Model 9000 Windrower Tractor NATURALLY ASPIRATED MUFFLER REPLACEMENT INSTALLATION INSTRUCTIONS

NOTE: The muffler you ordered is no longer available, so use this instruction to retro-fit the new muffler and parts you received.

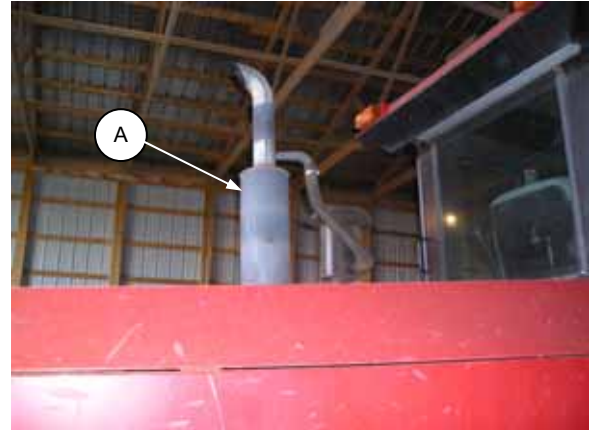
1. Loosen hardware on muffler clamp and aspirator hose connection at the muffler.
2. Remove existing muffler (A) from the engine.

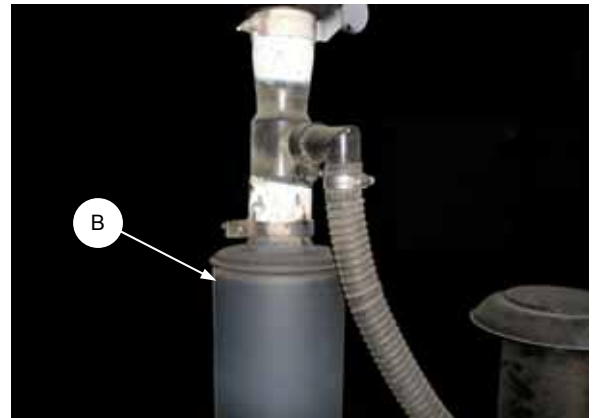
3. Assemble new muffler (B) as shown in photo.
NOTE: New muffler needs to have upper bent stand pipe section of pipe cut off to allow installation of new components as shown in photo.
NOTE: Be sure to leave enough straight pipe on muffler to allow installation of new components.
4. Using existing clamp, clamp muffler onto engine stand pipe and tighten clamps.

5. Attach aspirator hose (C) to new muffler using existing clamp.
NOTE: Air cleaner may need to be loosened and rotated so that hose reaches connection.
